# Change of SAR attenuator setting for ScanSAR HV mode

JAXA EORC & ALOS-2 Project Team

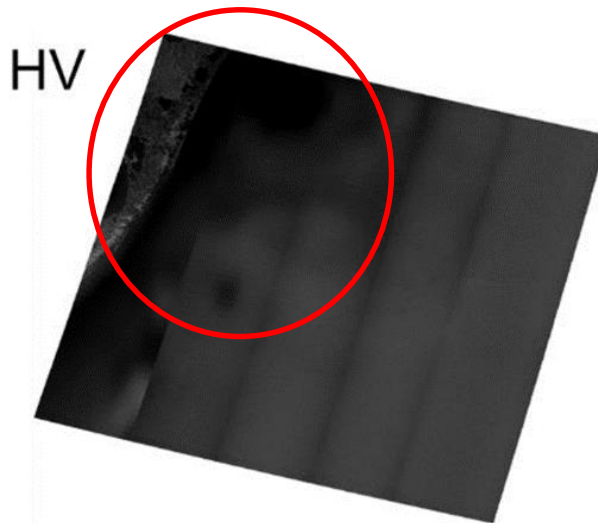
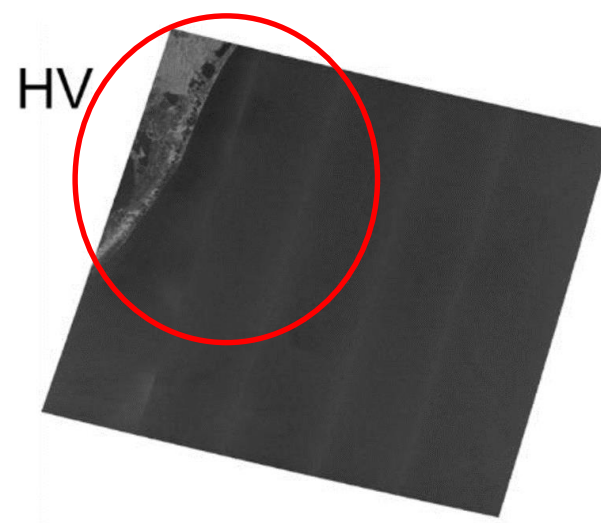
- It was found that the ScanSAR HV-polarization images sometimes became dark and blurred over ocean and coastal regions.
- The cause of this issue was that the onboard ATT (attenuator) setting for ScanSAR cross-polarization was higher.
- On April 11, 2018, the ATT setting for ScanSAR cross-polarization was changed to 20 dB.

**Before ATT setting change**

**After ATT setting change**  
(test observation)

**ATT 25dB**, 2016/7/24

**ATT 20dB**, 2017/12/10

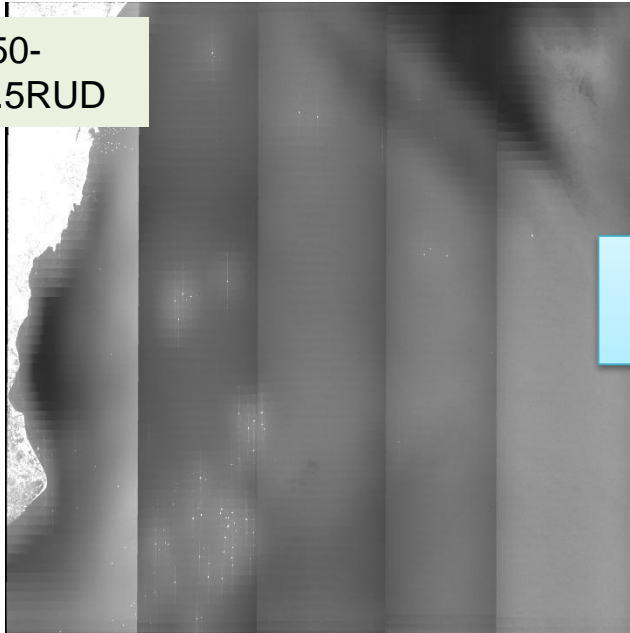
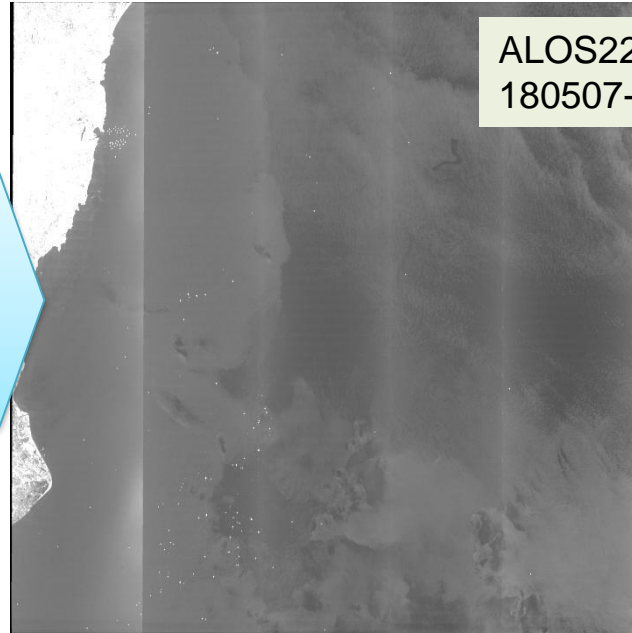
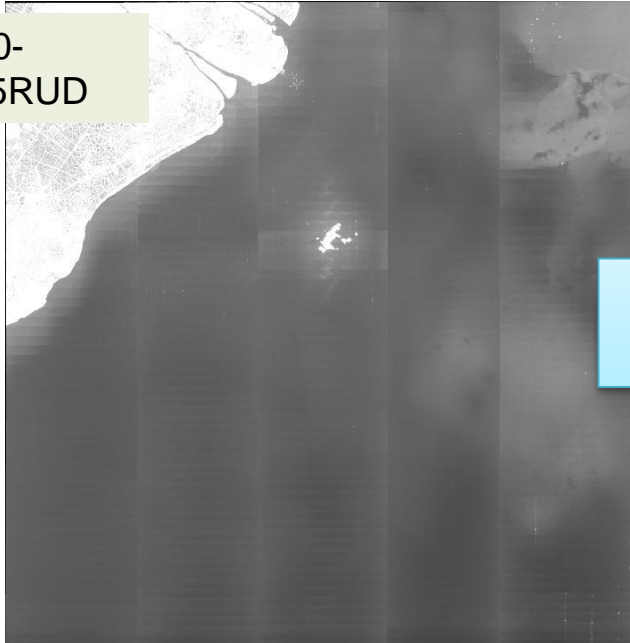
## Before ATT setting change

## After ATT setting change
